## HISTORIC AND DESIGN REVIEW COMMISSION

HDRC CASE NO: 2020-227
ADDRESS: 102 BUFORD

**TYPE OF WORK:** Adding porch decking onto existing concrete

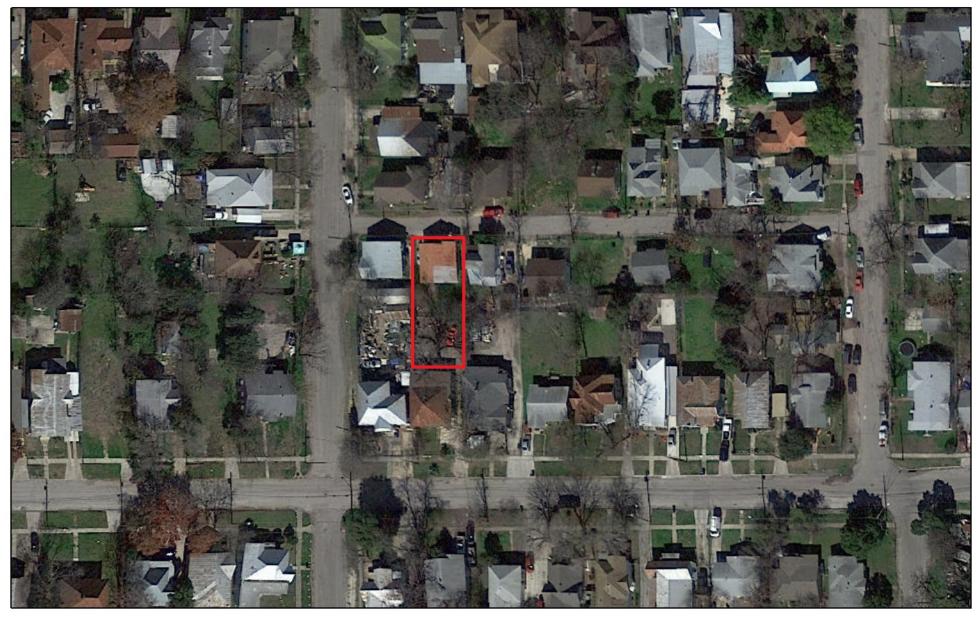
- b. PORCH DECKING As noted in finding a, the applicant has proposed to install treated decking on top of the existing concrete porch. The proposed decking would be installed on top of 1 ½" treated lumber. The Guidelines for Exterior Maintenance and Alterations 7.B.iv. notes that replacement elements should be simple in nature as to not distract from the character of the historic structure. Additionally, the Guidelines for Exterior Maintenance and Alterations 7.B.v. notes that the architectural style of the structure and historic patterns should be the basis for added elements. Staff finds the proposed decking to be inconsistent with the Guidelines and architectural style of the house. Staff finds that tongue and groove decking be installed that features width of three (3) inches and

heights of approximately (1) inch. Tongue and groove decking is to be installed perpendicular to the front façade, rather than parallel, as proposed.

i. That tongue and groove decking be installed perpendicular to the front façade, and feature a width of three (3) inches and a height of approximately one (1) inch.
